Application Number: PL2024188

Application Type: Commercial Final Development Plan

Application Name: Joint Operations Facility

Analysis of Commercial Preliminary Development Plan:

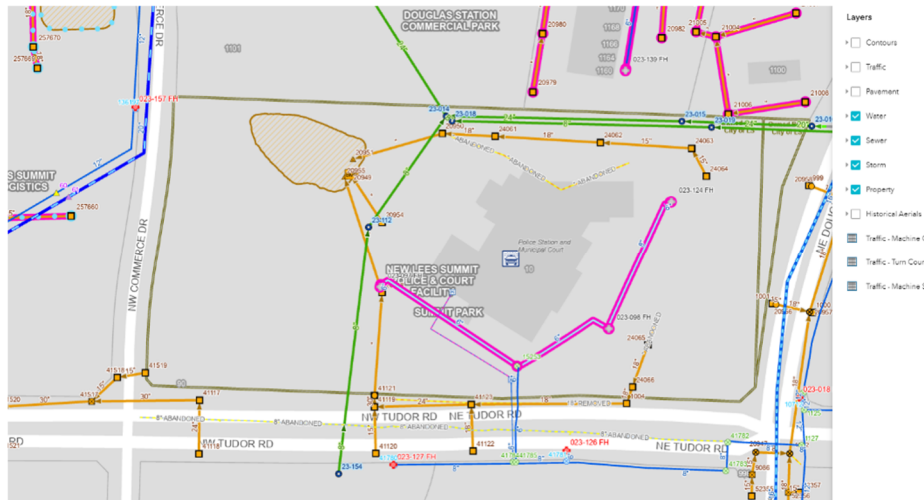
1. Final Stormwater Report dated Oct. 16, 2024 (hereinafter referred to as "the stormwater report") appears to be presented as a preliminary stormwater detention report. There are numerous references to "final design to provided with the Final Development Plan". Report shall be final in terms of the design, including the relationship between the clogged condition and the top of dam, which appears to conflict what is discussed in the text of this preliminary stormwater report, and what is shown in one of the exhibits towards the end of the preliminary stormwater report. Corrections required.

- a. Response: Acknowledged. Report will be updated to remove any references to final design. All design information will incorporated into the report or project plans.
